# Simplified classification in the State Diagram II v100

This baseline is the follow up to [yeseboodt\\_01\\_1116\\_simpleclass.pdf](#). Aims are as follows:

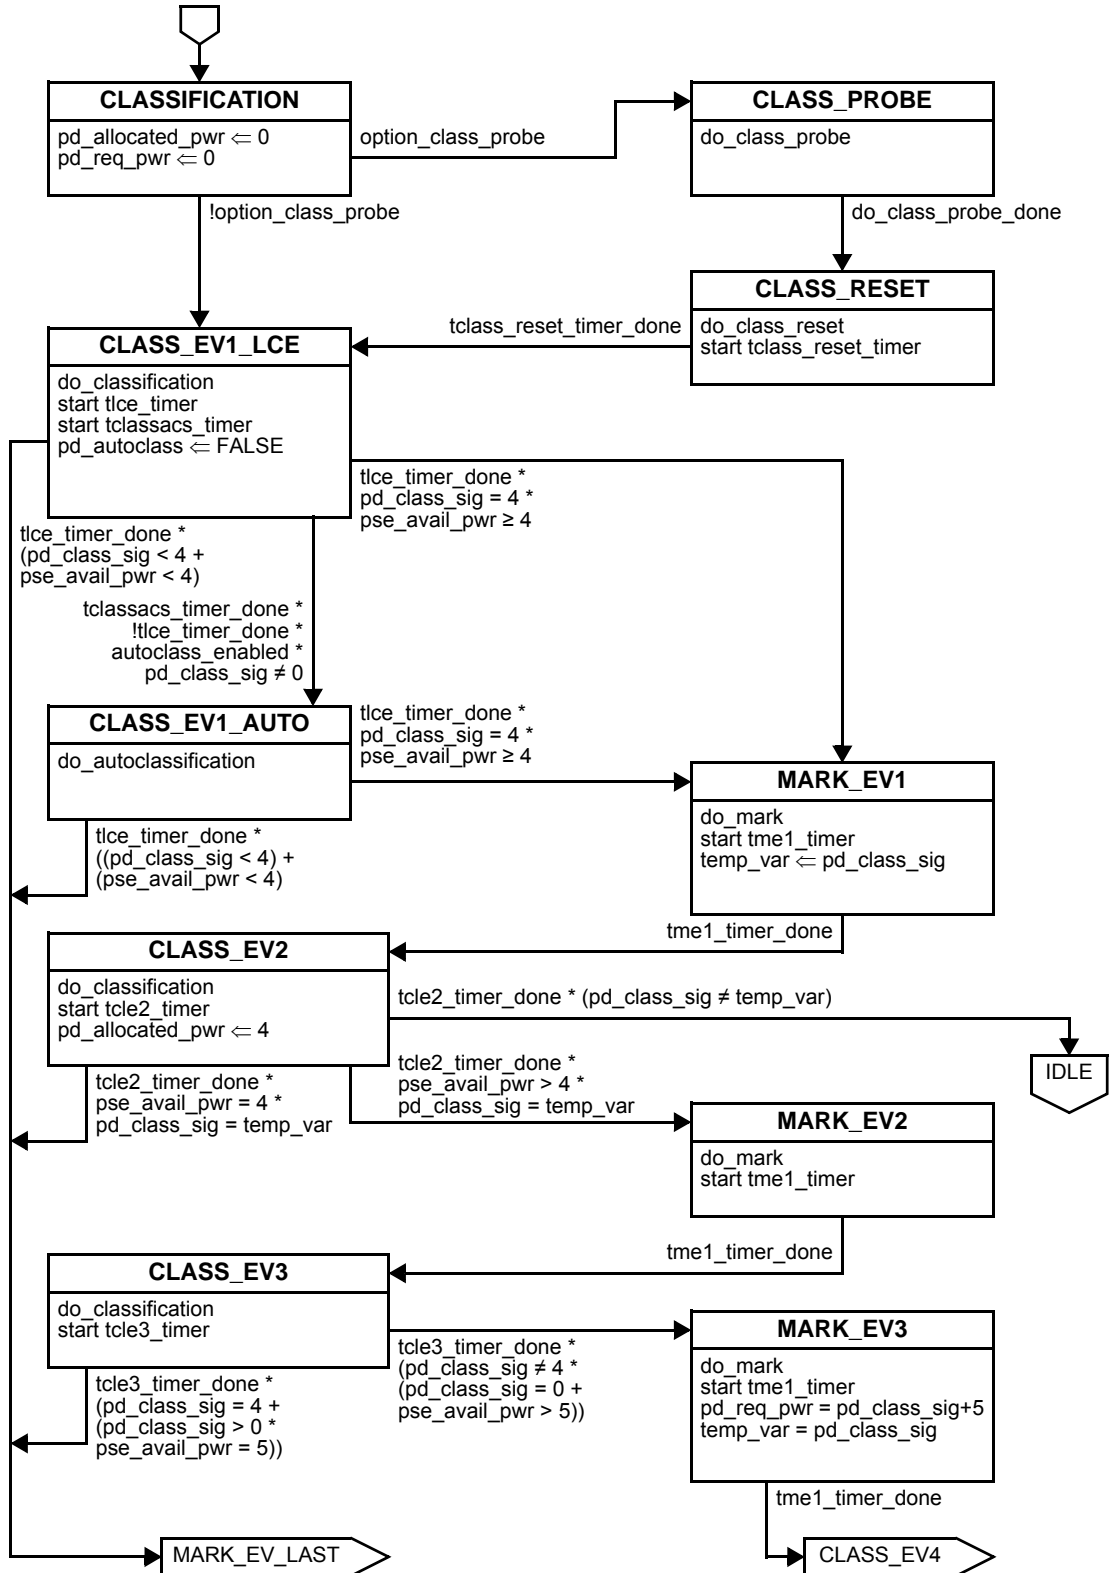
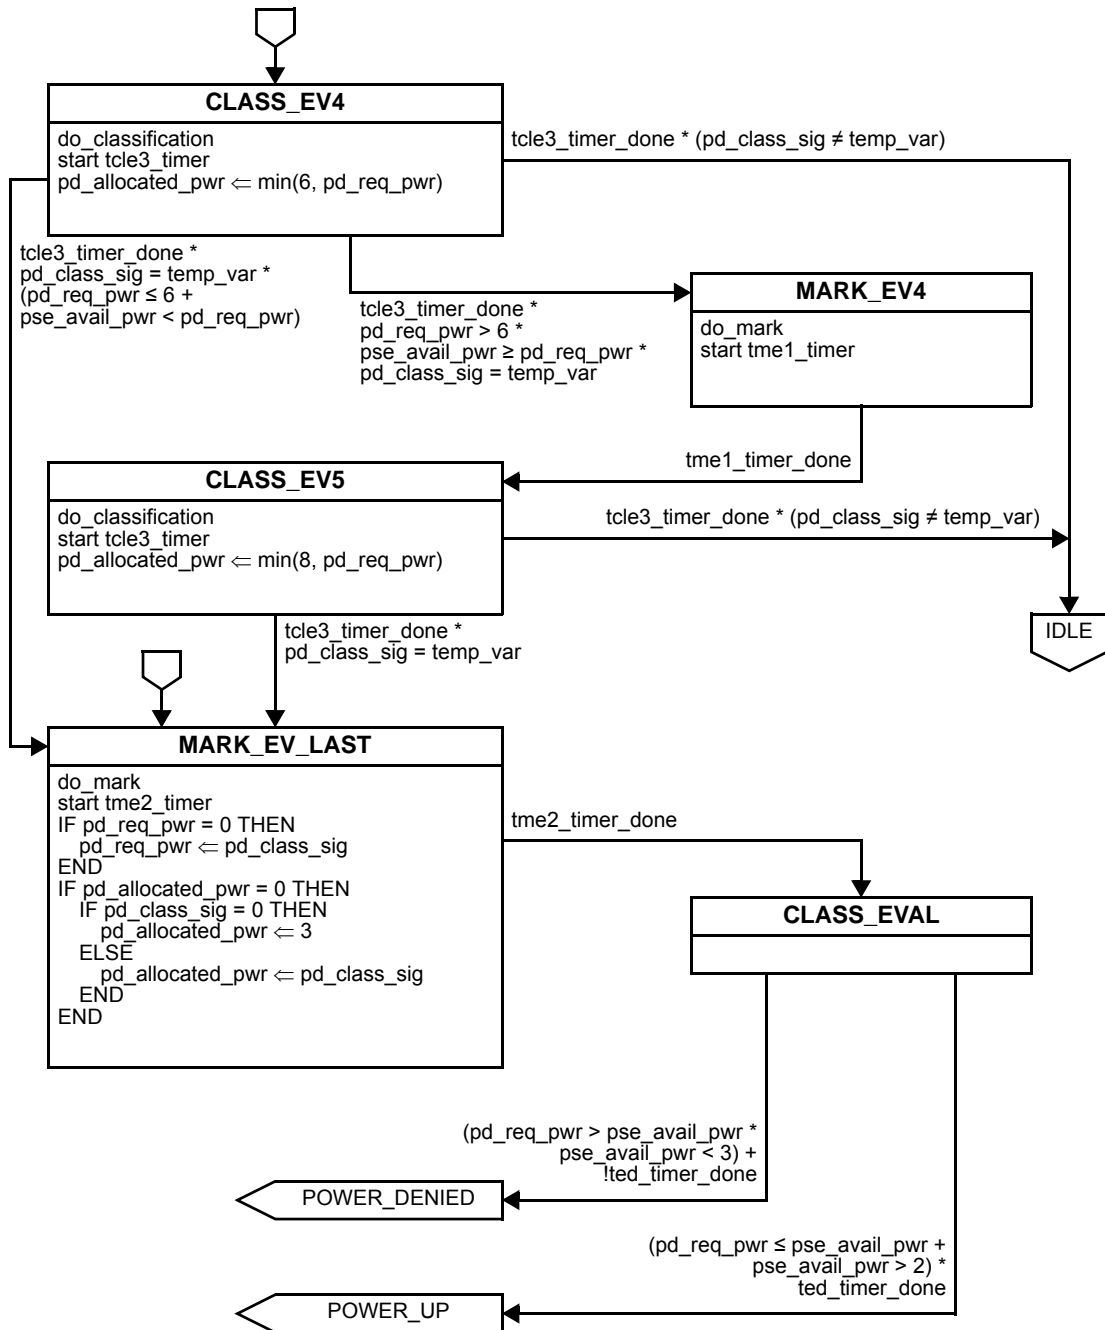
Change the arcs going from *DETECT\_EVAL* and *CXN\_CHK\_DETECT\_EVAL* to *CLASS\_EV1\_LCE* to go to *CLASSIFICATION* in stead.

Remove the *CLASS\_EVAL* state from page 95.

Replace the classification SD on page 97 as follows:
